| Model | | ARDF for M210 ,NC11, and N230 (Ricoh DF57, Savin 9180, NRG RF 3020, infotec ARDF IV/II) | | | | | | Volt/Hz | Date of Modification | Serial Number | |
| Modified Article | | Decal - Mode Confirmation | | | | | | | | | |
| Reason for Modification | | To ensure normal mode setting | | | | | | | | | |

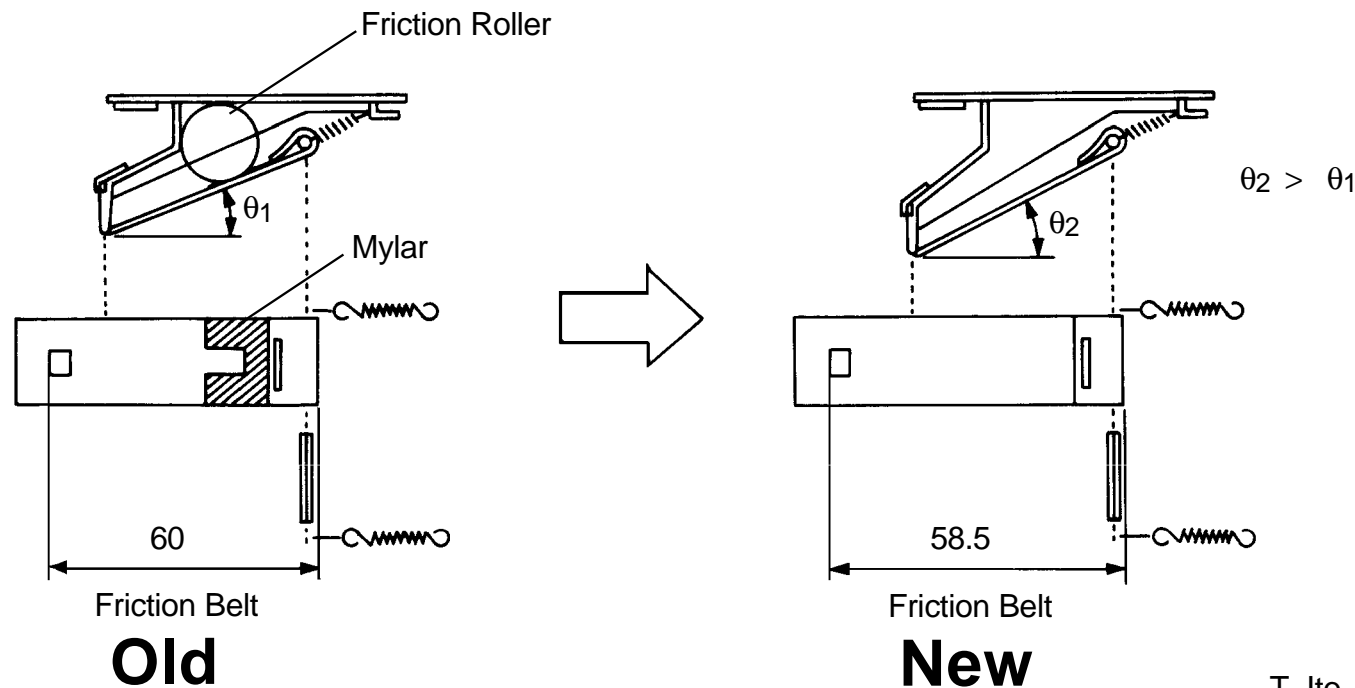
To ensure the original separation, we found that it is more effective to increase the angle (θ) as shown. These are the modifications on production machines to change the angle from θ_1 to θ_2 :

1. The friction roller has been removed.
2. The mylar on the friction belt has been removed.
3. The dimension of the friction belt has been changed.

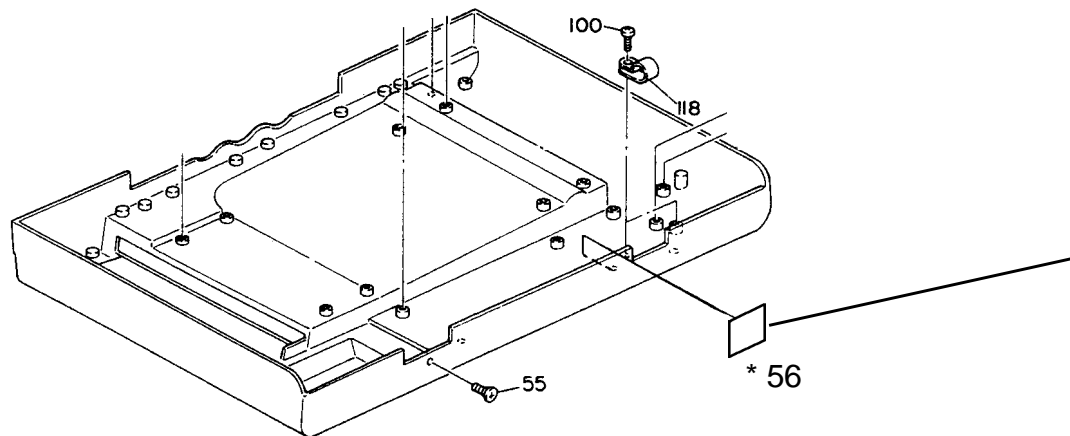
The feed-in motor is now procured from the new vendor and the part number has been changed. To meet the UL standards for the new motor, the fuse specification printed on the main board has been changed from "FU101 3A" to "FU101 F3A/125V, and a caution decal has been added to the inside of the DF upper cover. The old and new parts' interchangeability is O/O, except in the U.S.A.

For continued
protection against risk
of fire, replace only with same type
and rating of fuse.

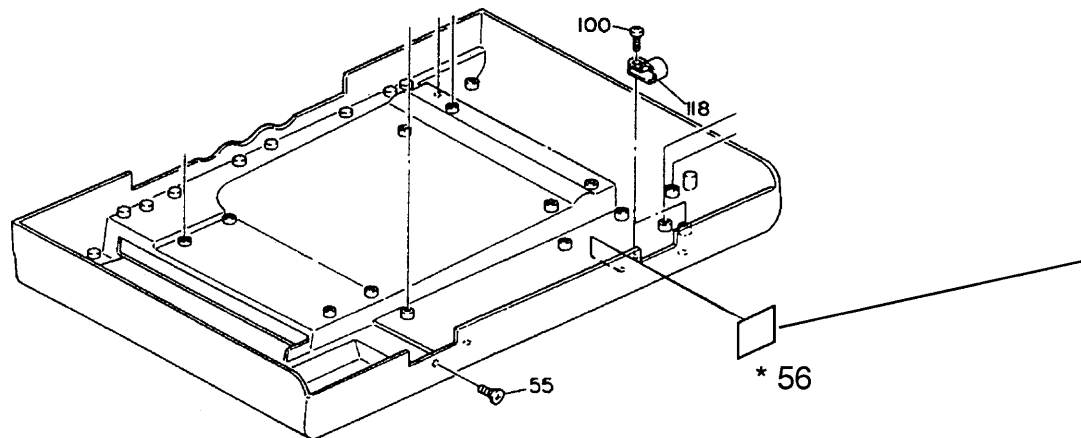
Because the feed- in motor has been discontinued, a new motor is supplied. To meet the UL standards, the main board has been modified to match the new motor used, and a caution decal has been added. The fuse specification printed on the main board has been changed from "FU1 01 3A" to "FU1 01 F3A/125V, and a caution decal has been added to the inside of the DF upper cover.

NOTE : The feed-in motor (A3189500) is composed of the new feed-in motor and the decal (P/N : AA000072).
When installing the new motor on document feeders produced before this modification, attach the caution decal on the DF upper cover (see next page).

For continued protection against risk of fire, replace only with same type and rating of fuse.

1. EXTERIOR & TRANSPORT SECTION (A318) (Page 2)

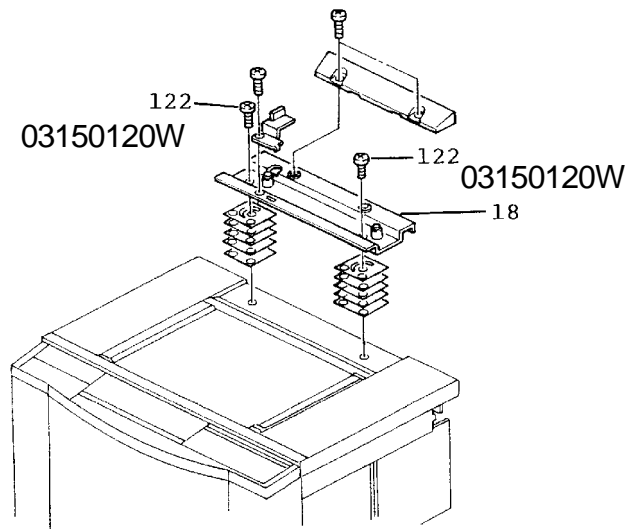
To install the ARDF onto the new product, these screws which secure the Mounting Bracket (Index # 18) is changed from 10mm long to 12mm.

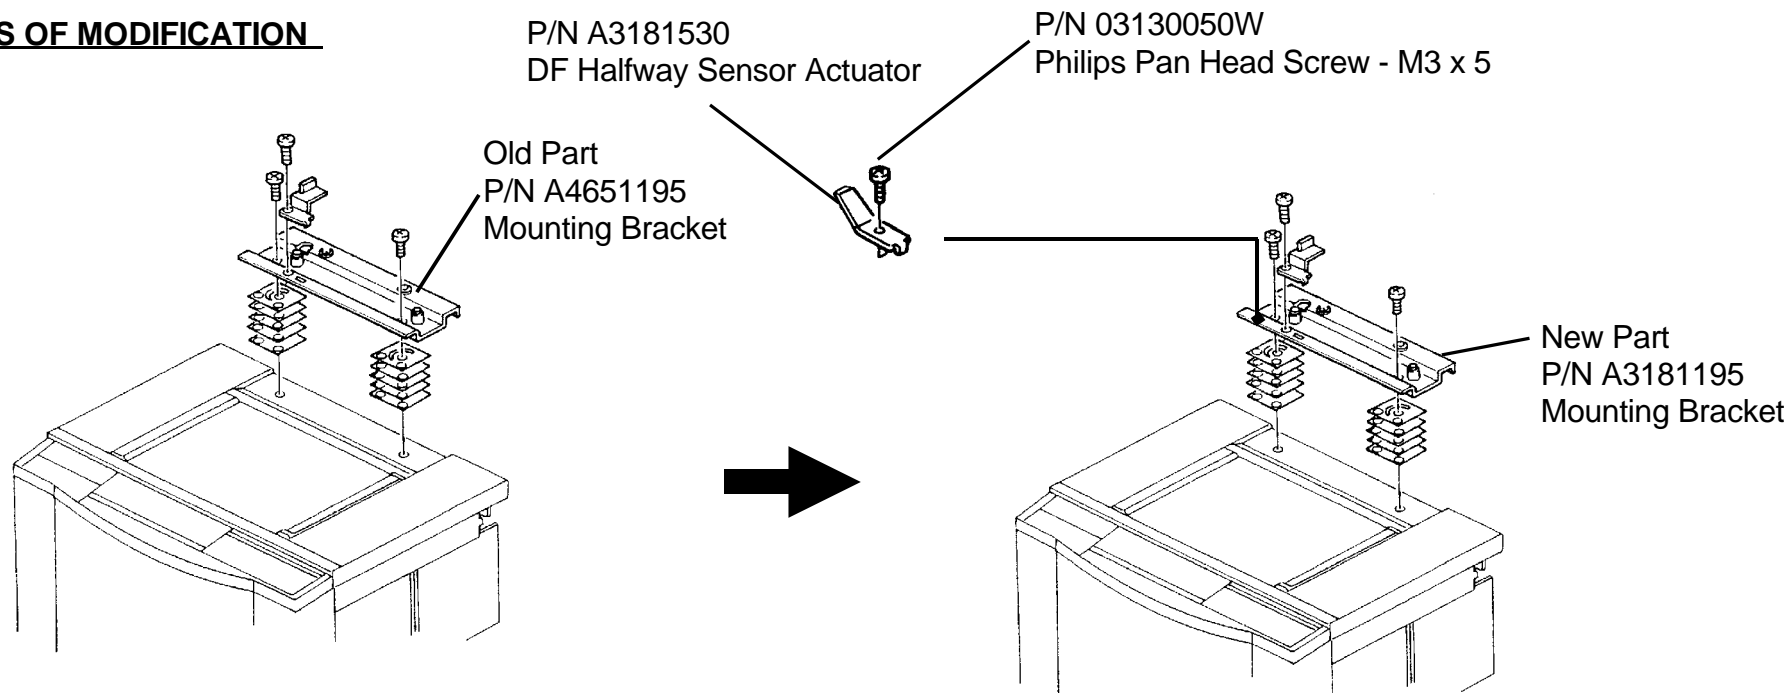
1. A screw hole and a positioning hole to accept a DF Halfway Sensor Actuator are added to the Mounting Bracket.
2. A Philips Pan Head Screw - M3 x 5 and a DF Halfway Sensor Actuator are newly added.

Note: Before, the DF Halfway Sensor Actuator could only be installed with the Mounting Bracket "A3181191". By this modification, this actuator can also be installed with Mounting Bracket "A3181195". Since only one of the Mounting Brackets (A3181191, A3181195) is used to install the ARDF on the copier, the quantity of Actuator (A3181530) and fixing screw (03130050W) as accessory parts of the ARDF are the same.

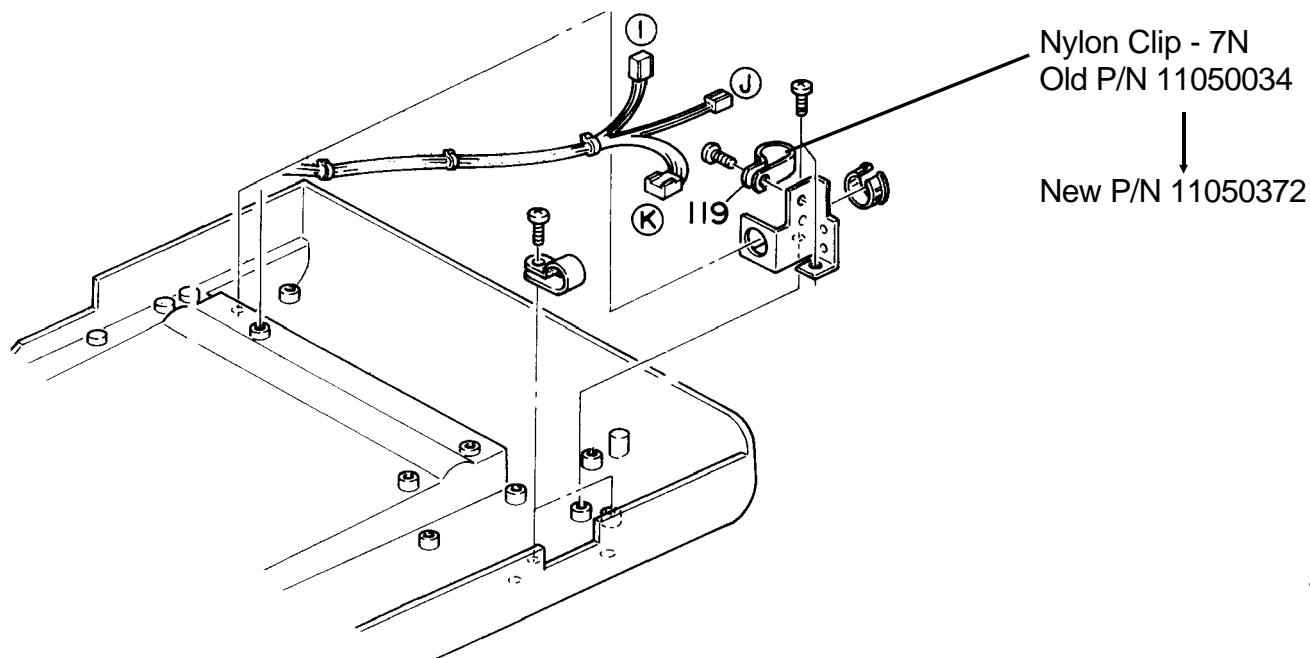
To meet UL standard a harness clamp has been modified to UL approved type. The interchangeability is X/O.

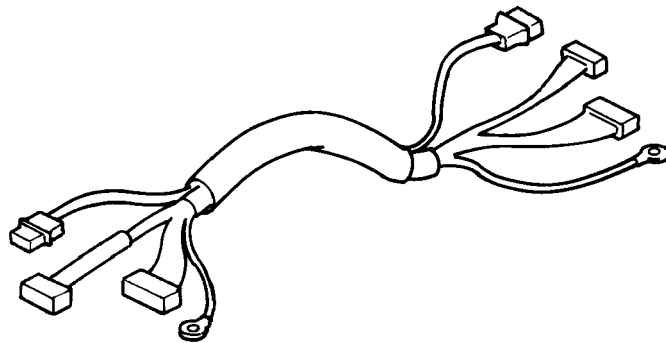
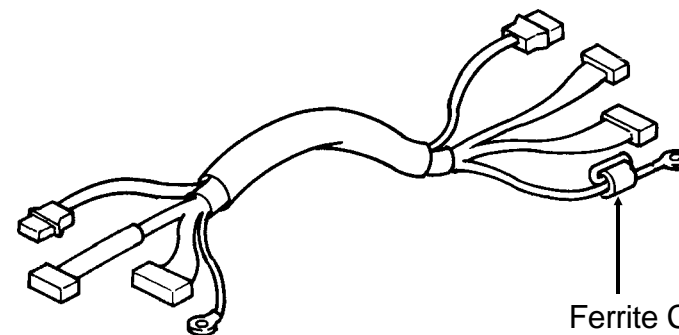
A ferrite core has been added to the interface harness.

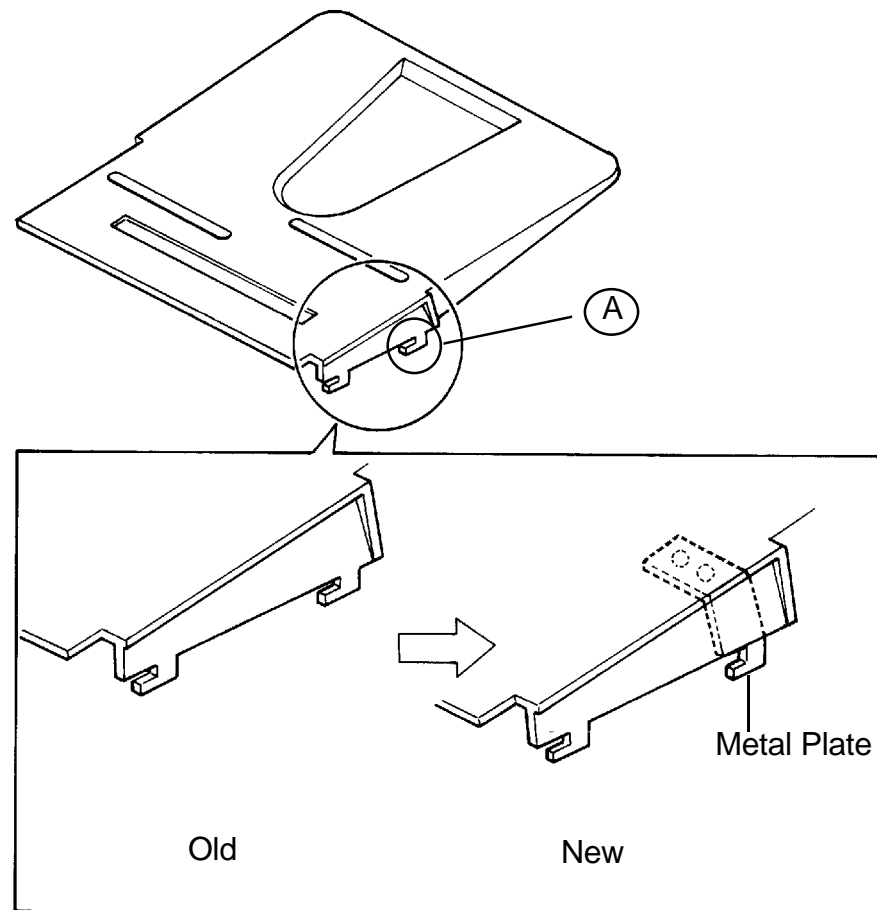
The operators often open and close the DF by holding the original table. After about 1000 ~ 3000 times, (A) of the original table will break. To prevent this problem, the material of (A) has been changed to metal.

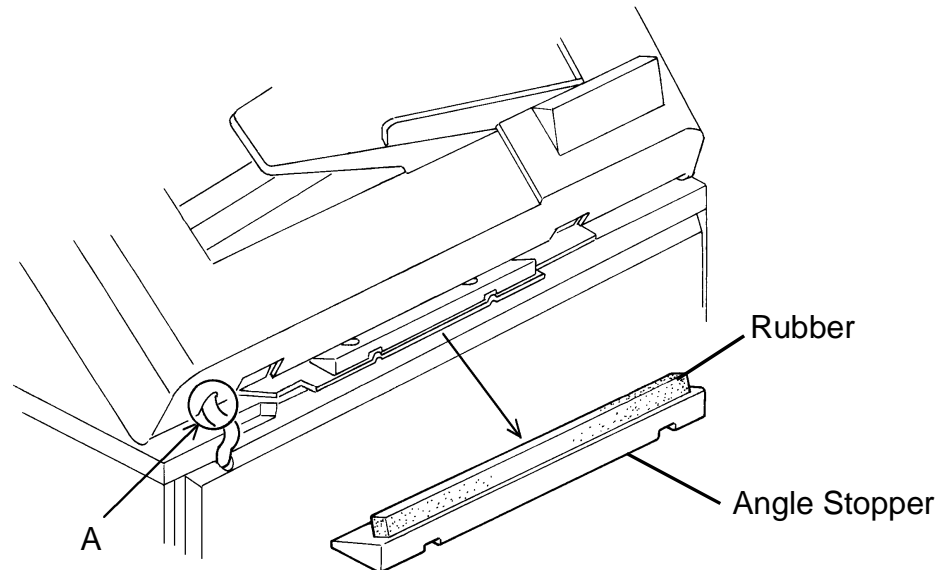
After the operator many times opens and closes the DF which is installed on the N230, the platen cover/DF position sensor harness will break at the position (A) in the following figure. To prevent this problem, a rubber has been added to the angle stopper.

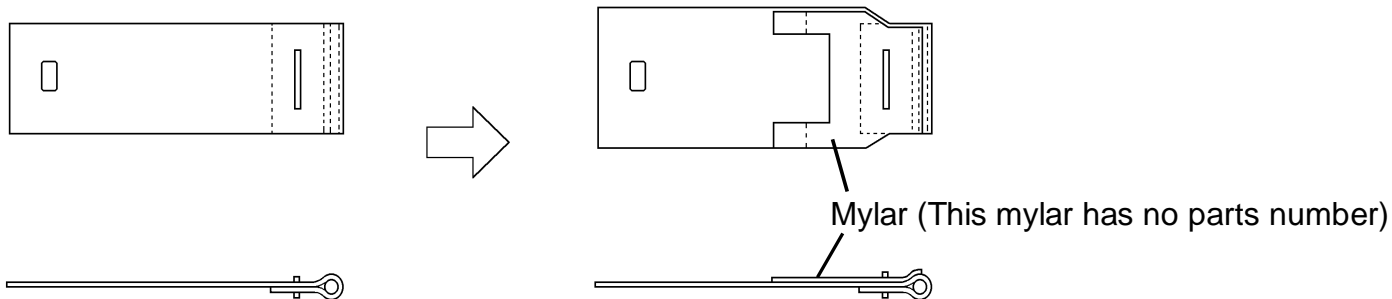
1. Friction Belt Holder : The configuration of the friction belt holder has been changed as shown.

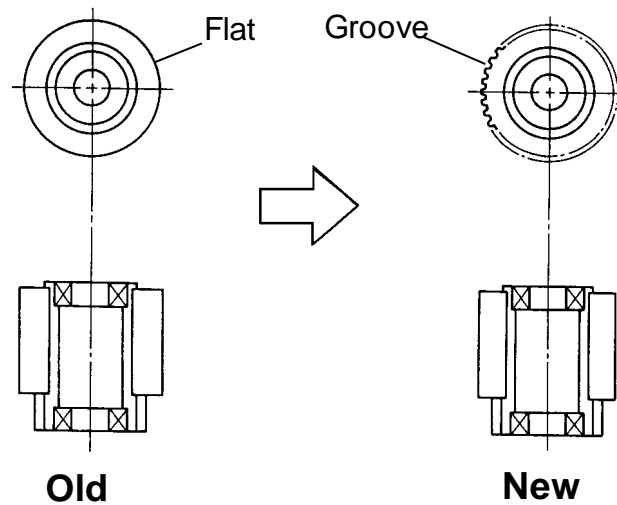
2. Friction Belt : The configuration of the belt has been changed and a mylar has been added to improve feeding of the original.

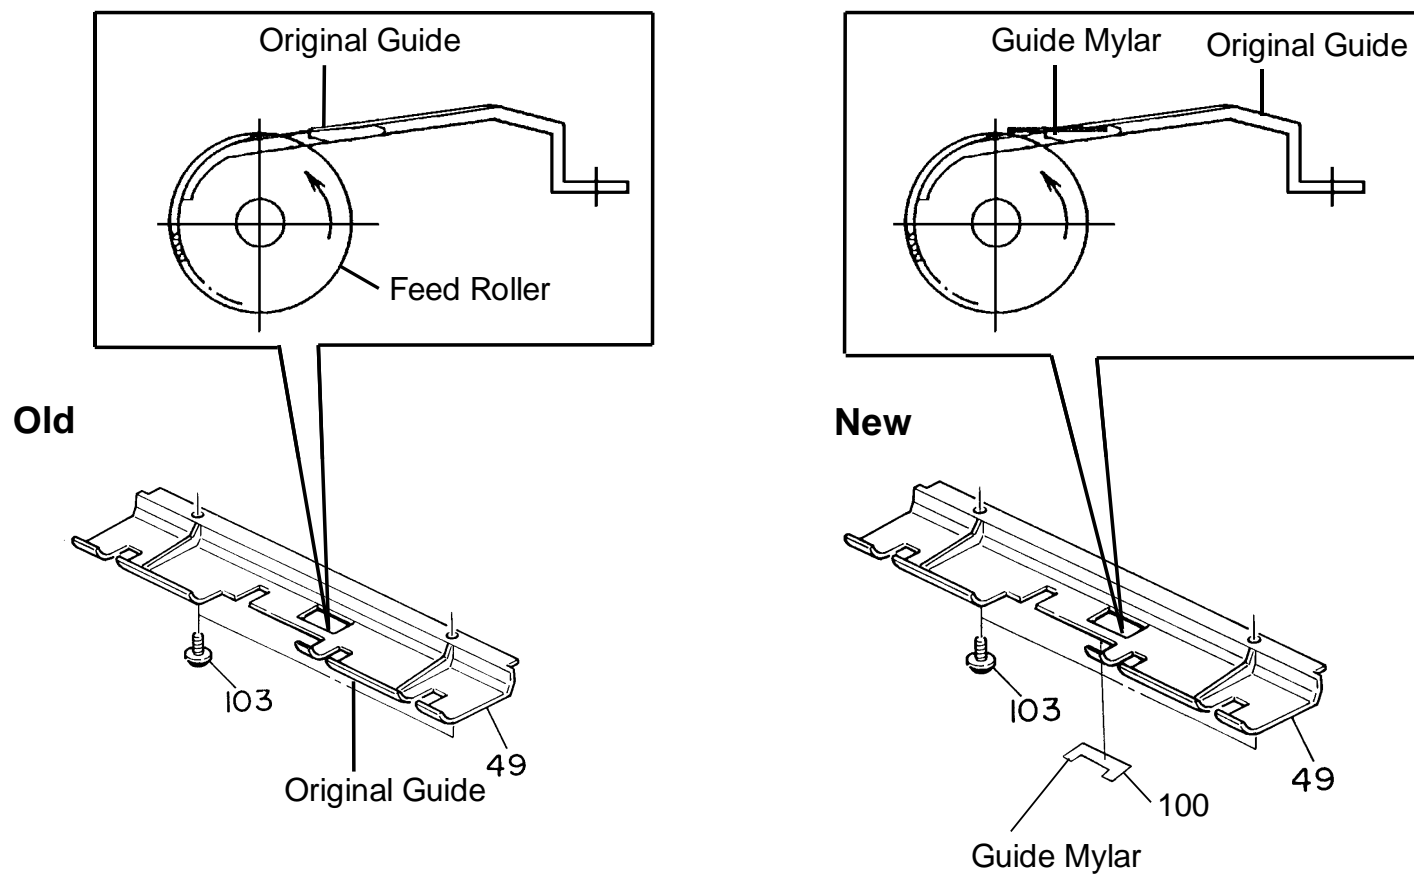
3. Original Feed Roller : To improve feeding of the original, the groove has been added to the feed roller.

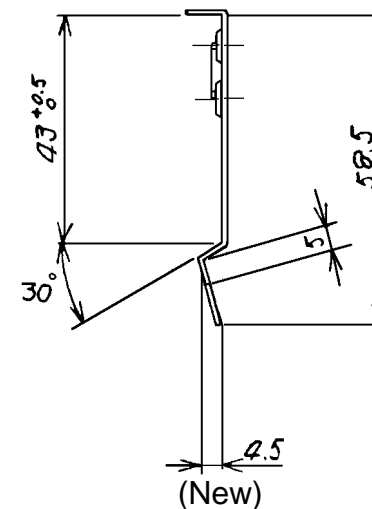
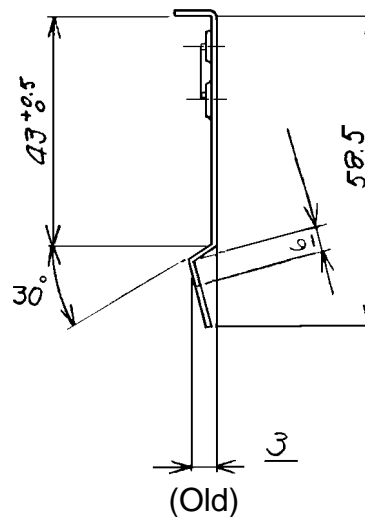
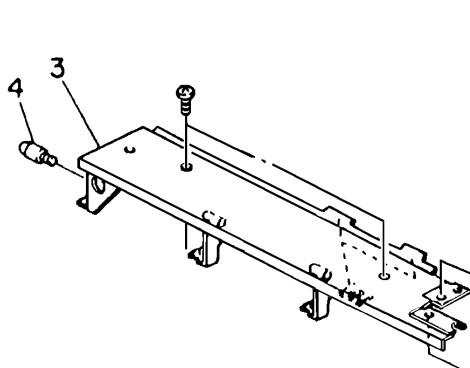
The DF registration sensor is activated by paper dust on the sensor pad, affecting its color. This is because, when the original roller starts rotating, the DF upper plate is warped slightly downward. The clearance between the DF registration sensor and the sensor pad is reduced. To prevent this the pull-out bracket has been modified to improve the clearance.

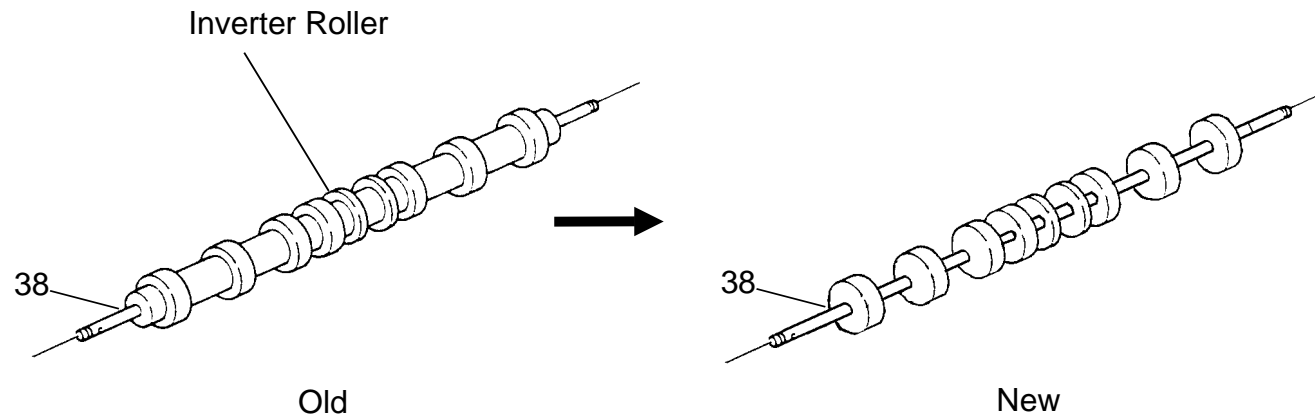
| Old P/N | New P/N | Description | Q'ty Used | Inter-change-ability | Parts Catalog | |
|----------|----------|-----------------|-----------|----------------------|---------------|------|
| A4221210 | A4972090 | Inverter Roller | 1 → 1 | O/O | 38 | 7 |

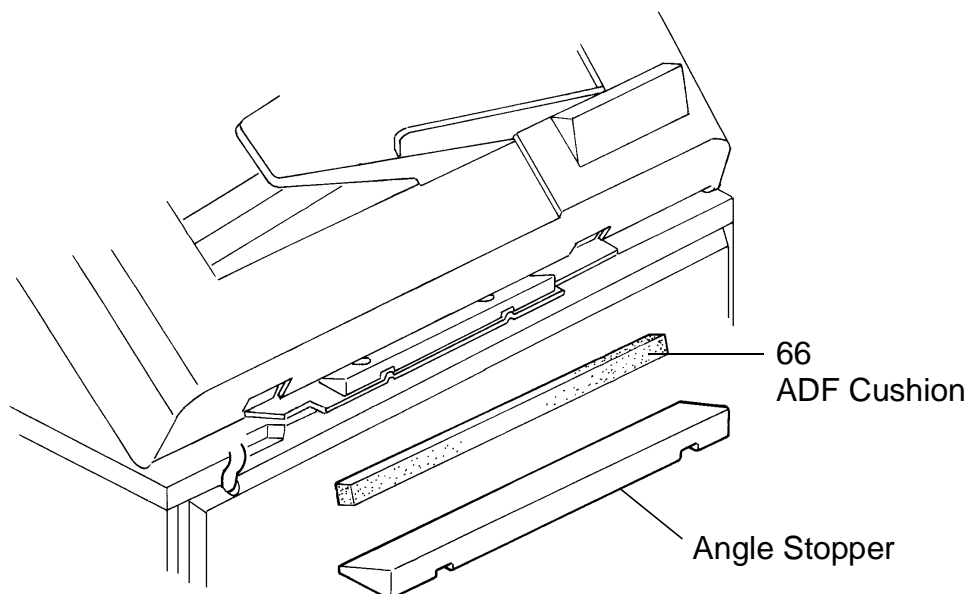
| New P/N | Description | Q'ty | Index No. | Page |
|----------|-------------|-------|-----------|------|
| A3181560 | ADF Cushion | 0 → 1 | 67 | 3 |
